10 May 2024

**COMMENTS ON THE DRAFT ENVIRONMENTAL IMPACT ASSESSMENT REPORT FOR THE PROPOSED AFRICA OIL SA CORP BLOCK 3B/4B OFFSHORE EXPLORATION
EIMS REF: 1570**

PASA/DMRE REF: 12/3/339

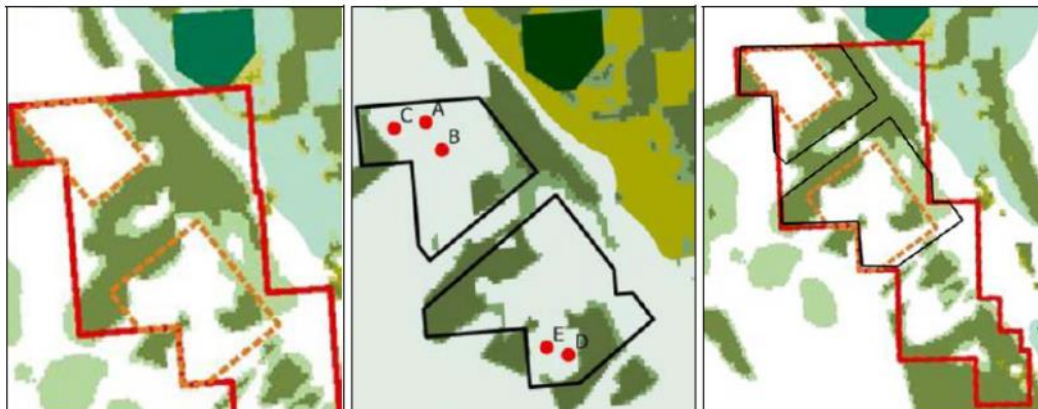
12. Additionally, Appendices 4.9 and 4.10 state that the two modelled release points (A and D) were selected based partly on the “[p]roximity of marine protected areas (MPAs) and critical biodiversity areas (CBAs) that might be impacted ... (see Figure 1)”. Since Figure 1 in both appendices depicts an Aol and biodiversity areas that differ from those used in the main body of the EIA, it is possible that these points do not reflect the worst case locations with respect to CBAs (See Figure A).

13. Because of this discrepancy in the extent of the Aols and the proximity of the “indicative target points” to nearby protected areas, it is impossible to ascertain whether the oil spill models truly reflect the worst-case scenario. At the very least, the authors of the RDEIAR should clarify the extent of the Aols, the proximity of indicated well-locations to protected

Figure B. Map of petroleum exploration and production activities in South Africa from Petroleum Agency SA.²²

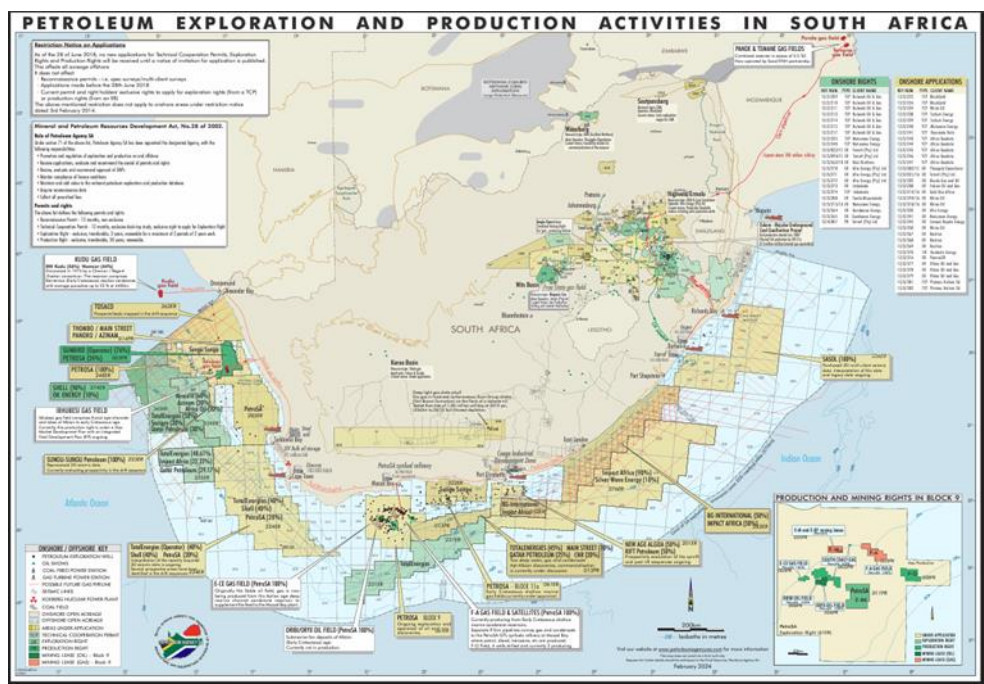
43. In addition, The RDEIAR fails to fully consider the proposed project's cumulative impacts: specifically, how the proposed project would add to existing stressors from current and proposed offshore activities.

44. The map below shows current oil exploration and active petroleum production activities. These activities cover the majority of South Africa's waters, with over 300 wells already drilled.

Figure C. Map of cumulative anthropogenic pressure from 2018 National Biodiversity Assessment Report

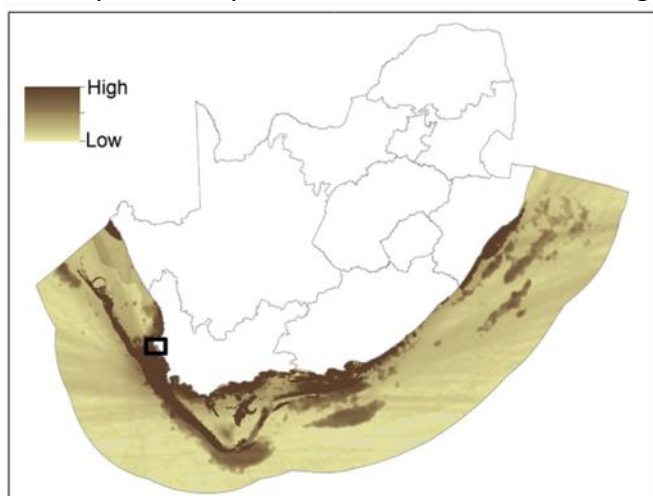
pressures and impacts (See Figure C). The study notes that: “areas of high cumulative pressures translate into areas of severe ecosystem degradation and poor ecosystem condition, particularly in the inner shelf and shelf edge...”²³

46. The RDEIAR notes, based on this map, that “3B/4B is located in an area experiencing very low cumulative impacts from other users and that the ecological condition is therefore mostly still natural or near-natural.”²⁴ But, its cumulative effects analysis is focused on the footprint of the proposed project. What is missing is an evaluation of how increased anthropogenic impacts in one of the few remaining areas of South African waters that is considered to be in a “near-natural” condition could influence the total amount of habitat available to marine biodiversity in the offshore environment. The continued loss of “natural” environments is especially concerning, given the possibility of several concurrent or future activities in the vicinity of 3B/4B.²⁵

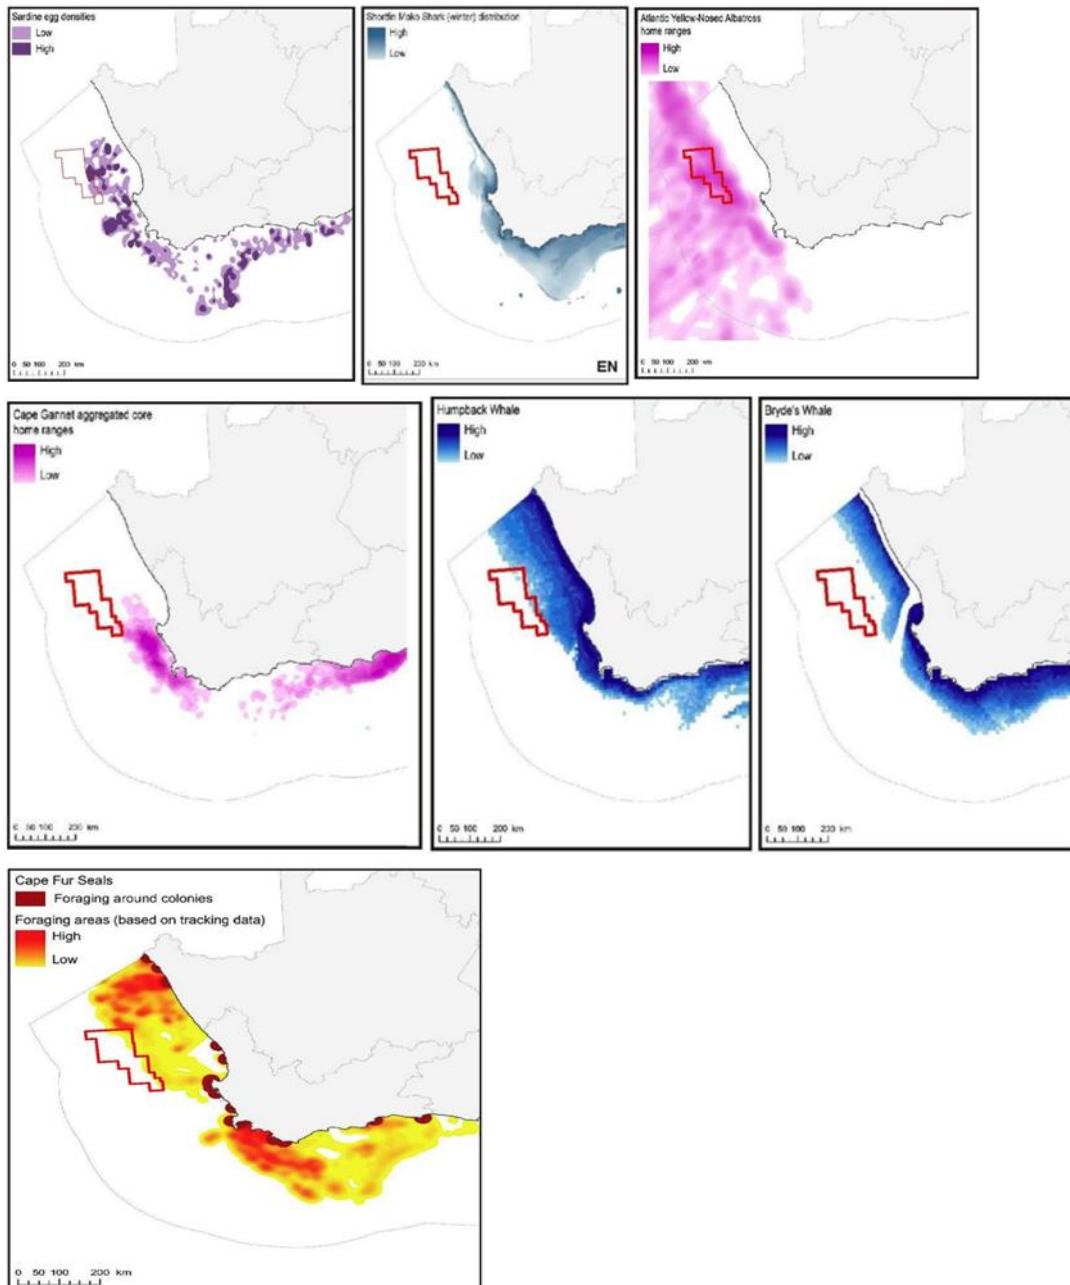
56. The RDEIAR provides many maps showing the distributions of fishes, birds, and mammals that overlap with the area of the modeled oil spill scenarios. The examples below were taken from Chapter 8.3 of the EIA, and illustrate the diversity of species (many of which are listed by the IUCN as Endangered, Threatened, or Vulnerable) that could be impacted by an oil spill and/or the use of dispersants. The red polygon in each figure corresponds to Block 3B/4B.

58. However, the RDEIAR used a matrix to assess impacts that combines all of these species groups together.³⁹ This has the effect of averaging impacts across all marine fauna and habitats. By doing so, potentially extreme impacts on some species groups (seabirds, turtles, seals, etc.), are masked by predicted lower and short-term impacts to other groups (benthic species, rocky coastal ecosystems, etc.). The true impacts of the proposed project would be better understood by the public and decision-makers if the RDEIAR expanded its assessment matrix to consider the potential impact significance for each faunal group and habitat separately, and for each oil spill scenario (condensate and crude).

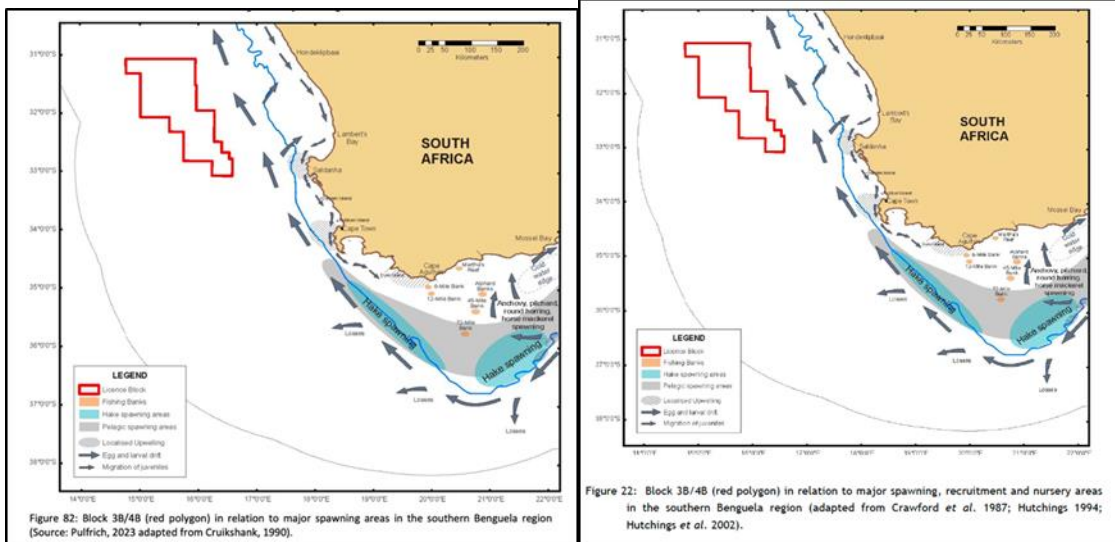
62. For example, the EIA reports that offshore bottom (demersal) dominates contributions to wholesale value of the South African commercial fishing sector, and Table 24 (from page 169 of the EIA document) reports that hake are the only species caught by that sector (both deep and shallow water species of *Merluccius*). Thus, the life history and ecological characteristics of relevant hake species are of particular interest with respect to their potential vulnerability with respect to offshore hydrocarbon exploration. However, it is difficult to assess the relative risks or potential impacts of the project on hake species because the information provided is insufficiently detailed and not properly cited. For example, Figure 82 (from p. 171 of the EIA document, see below) depicts presumed spawning and fishing banks for hake; however, it does not clarify which species of hake the data represent nor which fishing grounds or if those grounds are an exhaustive depiction of all grounds or only some examples of where fishing is known to occur. Furthermore, the figure is used twice—once in the main EIA report (Fig. 82 on page 171) and once in Appendix 4.6 (as Fig 22 on page 52) but credited to two different sources, making it particularly difficult to understand what information is being shown or how robust it might be.

63. When the image is shown in the main body of the EIA report (image on the left), it credits the source as “Pulfrich, 2023 adapted from Cruikshank, 1990” while Appendix 4.6 credits the source as “adapted from Crawford *et al.* 1987; Hutchings 1994; Hutchings *et al.* 2002”. Thus, it is impossible to verify the scientific soundness of the figure nor the associated designation of hake spawning grounds. It’s entirely unclear when/where/how the data regarding hake spawning or fishing was collected.
